# St Marys

## Heavy Vehicle Local Road report

Sydney Metro Western Sydney Airport Station Boxes and Tunnelling Works

# St Marys Heavy Vehicle Local Road Roadworks (Pre-Implementation) Road Safety Audit

**Table 4.2: Road Safety Audit Findings**

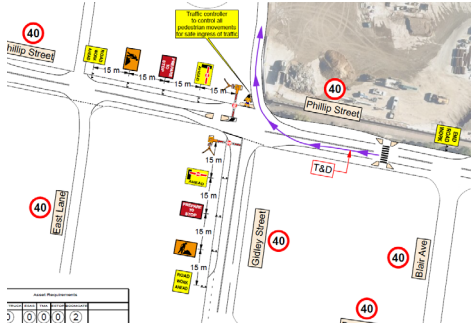
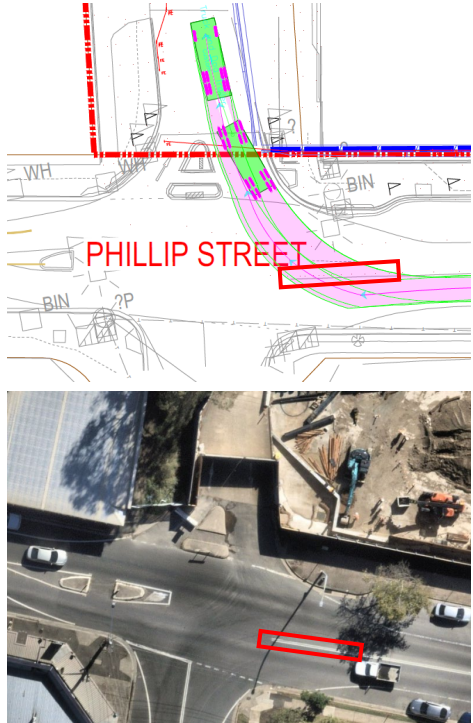
Item No.	Location	Descriptions of Findings	Photo / Design	Likelihood	Severity	Risk Rating	Designer Response
1.	South side of Phillip Street west of Gidley Street	<p>An 'End Road Work' sign is missing for traffic turning left onto Phillip Street onto Gidley Street.</p> <p>The Traffic Control at Work Sites manual requires 'End Road Work' signs to be placed to indicate that normal traffic conditions have resumed when 'Roadwork Ahead' signs have been used.</p>		-	-	Note Only	TGS updated to include 'End Road Works'.

2.	Phillip Street	<p>The portable boom barrier is located just east of the pedestrian refuge. Therefore, vehicles stopping before the boom barrier would impede pedestrian movements at this location.</p> <p>Pedestrians crossing Phillip Street outside the designated location may be exposed to moving traffic, especially when the boom barrier lifts, and thus increase the likelihood of vehicle-pedestrian conflicts.</p>		Possible	Moderate	High	TGS updated with portable boom barrier further east to reduce impact on pedestrian refuge.

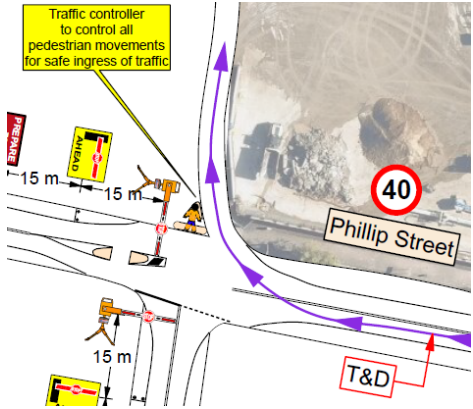
Item No.	Location	Descriptions of Findings	Photo / Design	Likelihood	Severity	Risk Rating	Designer Response
5.	Philip Street and Gidley Street intersection	There is no provision of 'No Entry' and 'Construction Vehicles Excepted' signage at the Gidley Street site access to prevent public thoroughfare.		-	-	Note Only	'No Right Turn' and 'Construction Vehicles Excepted' signage added to TGS
6.	Phillip Street Pedestrian Crossing	The design plan does not include a swept path diagram for the pedestrian crossing located to the west of Lethbridge Street to ensure the design vehicle does not encroach the traffic median on Phillip Street and would not impact on the safety of pedestrians storing in the refuge island.		-	-	Note Only	Swept Path has been included to display no impact on pedestrian refuge island
